PRODUCT/PROCESS CHANGE NOTICE (PCN)

PCN #: TB-0512-01 DATE: 16-Dec-2005 Product Affected: All IDT Products Shipped in Tape & Reel Date Effective: 16-Dec-2005	MEANS OF DISTINGUISHING CHANGED DEVICES: <input type="checkbox"/> Product Mark <input type="checkbox"/> Back Mark <input type="checkbox"/> Date Code <input checked="" type="checkbox"/> Other Reel color changed to black
---	--

ATTACHMENT I - PCN #: TB-0512-01

Additional alert label

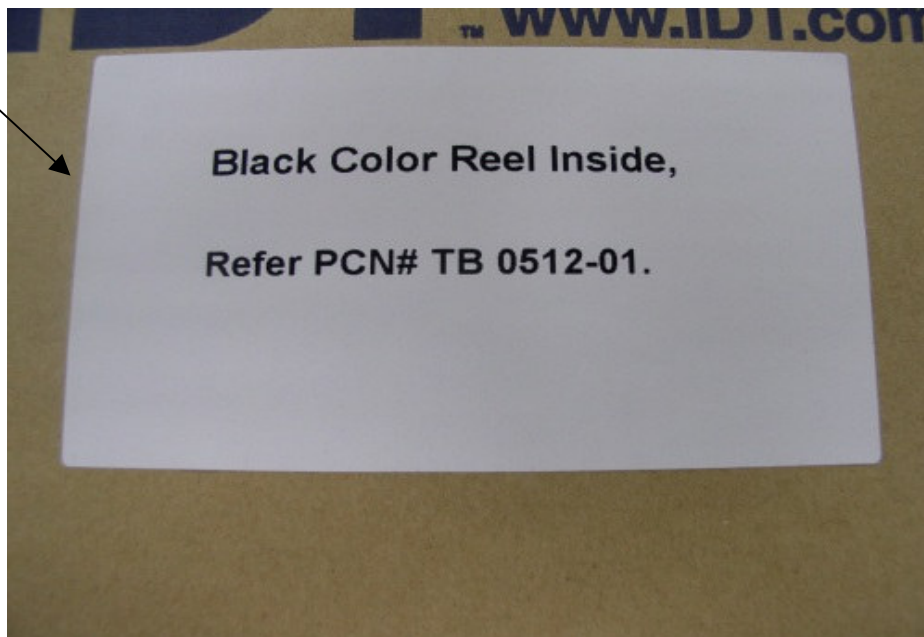
Conversion Schedule: Additional label will be placed on the intermediate box (pizza box) to alert customer of this change. Label will be placed starting 09-Dec-2005 until 09-Jun-2006.
